INN ROAD MOBILE SUBDIVISION

Engineering Comments: FINAL PLAT COMMENTS (should be addressed prior to submitting the FINAL PLAT for acceptance and signature by the City Engineer):

DETAIL SITE PLAN

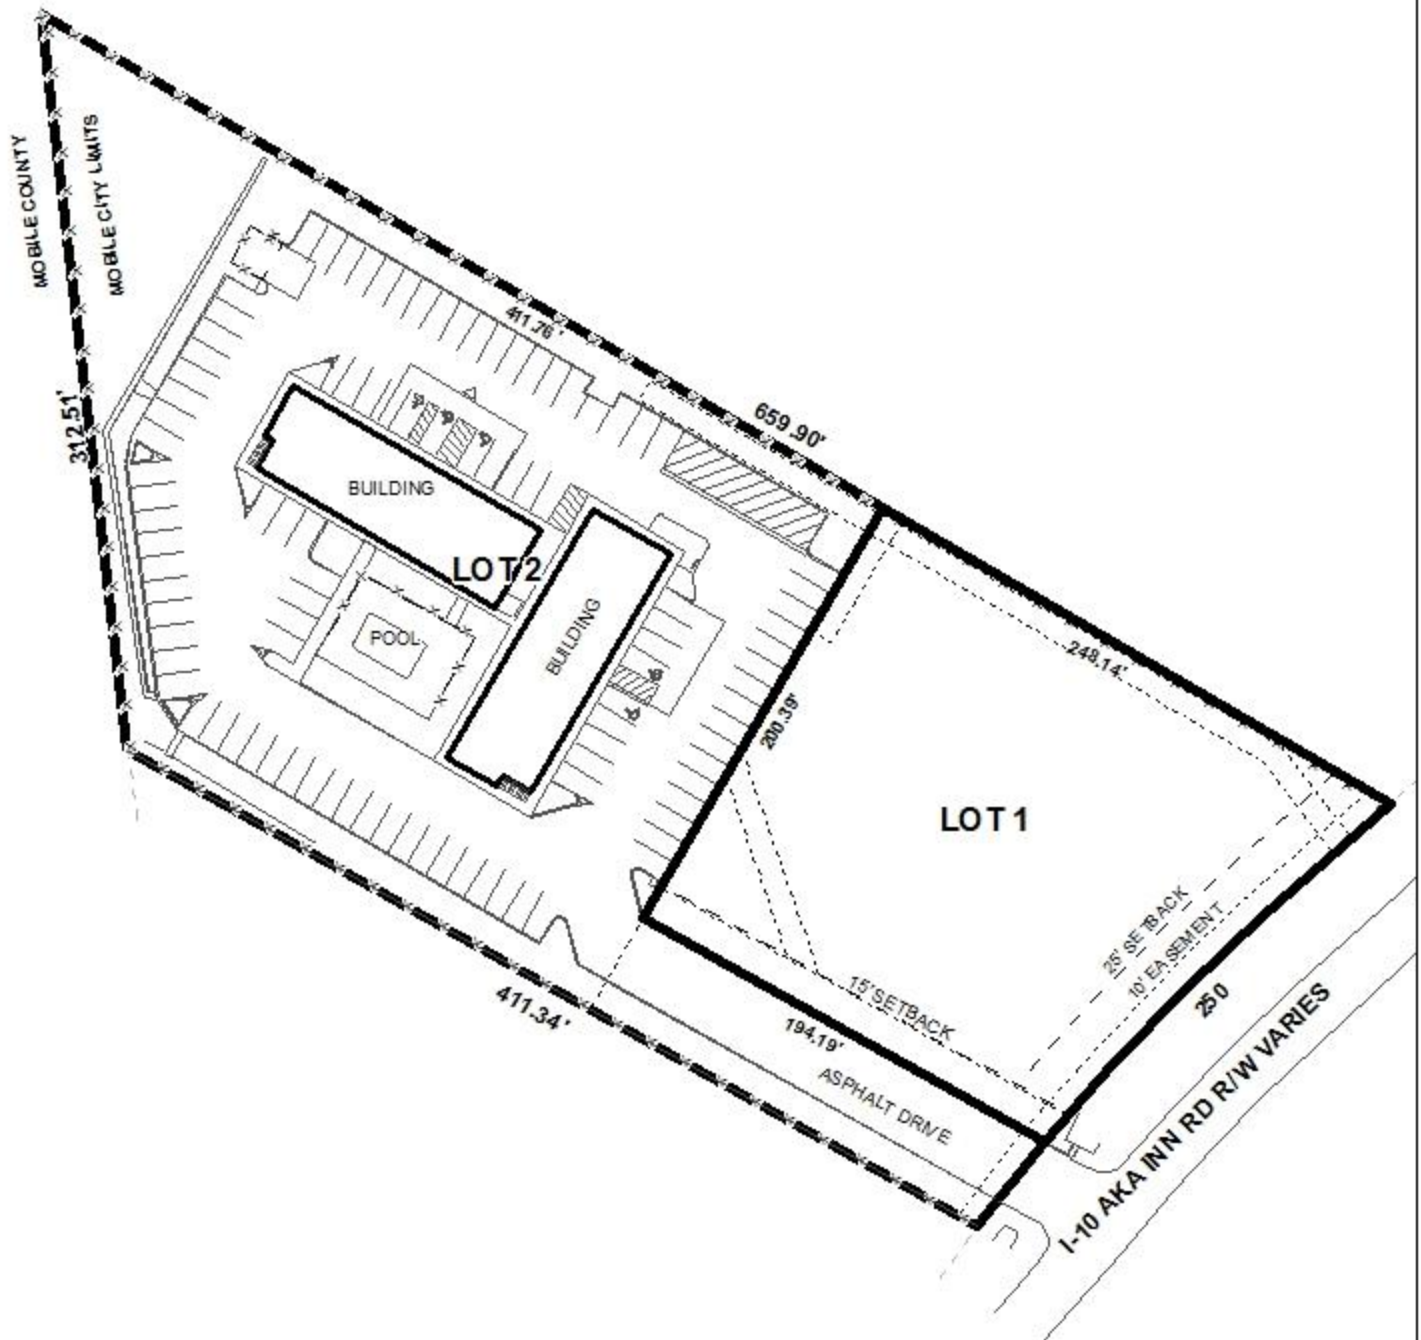
The proposed Lots front Inn Road a minor street without curb and gutter, and as such, a 60-foot right-of-way width is required. The preliminary plat states, "Varying Width Right-of-Way" and if approved, should be revised to illustrate the required right-of-way width or provision of adequate dedication to provide 30 feet from the center line of Inn Road

As proposed, Lot 2, if approved, would create a flag lot with a 45-foot-wide "pole" fronting Inn Road. It should be noted that per Section V.D.1. of the Subdivision Regulations flag lots are generally not allowed. However, the Regulations do provide some allowance when the proposed lot is located within an area where varied and irregularly shaped lot designs are common, and the design is consistent with other lots in the vicinity. As such, the proposed lot design may be appropriate as there are several irregularly shaped lots, including multiple flag lots, within the area of the proposed subdivision.

Additionally, flag lots large enough for future resubdivision per Section V.D.1. of the Subdivision Regulations requires that the "pole" of a proposed flag lot be of a width adequate to allow dedication and construction of a public road. As Lot 2 is large enough to potentially be resubdivided, if approved, the Final Plat should be revised to illustrate a compliant width of 60 feet for the "pole" of Lot 2 accounting for potential adjustments to Lot 1 made necessary by any increase in width.

The preliminary plat illustrates a 25-foot minimum building setback line for Lot 1 along Inn Road and should be retained on the Final Plat, adjusting as needed for any dedication. A 25-foot minimum building setback will be enforced where the vehicular access and pedestrian easement opens to the main body of Lot 2. As such, if approved, the Final Plat should be revised to illustrate the required 25-foot minimum setback along the access easement.

- 1) revision of the Final Plat to illustrate 30 feet of right-of-way or provision of adequate dedication to provide 30 feet of right-of-way from the center line of Inn Road;

- 2) revision of the Final Plat to illustrate a compliant 60-foot width for the “pole” of Lot 2 adjusting Lot 1 dimensions, if applicable;
- 3) revision of the Final Plat to illustrate the required 25-foot minimum setback along the access frontage;

- 5) retention of the 25-foot minimum building setback along Inn Road on the Final Plat, adjusting for dedication as needed;
- 6) placement of a note on the Final Plat stating that no structure may be placed or constructed within any easement;
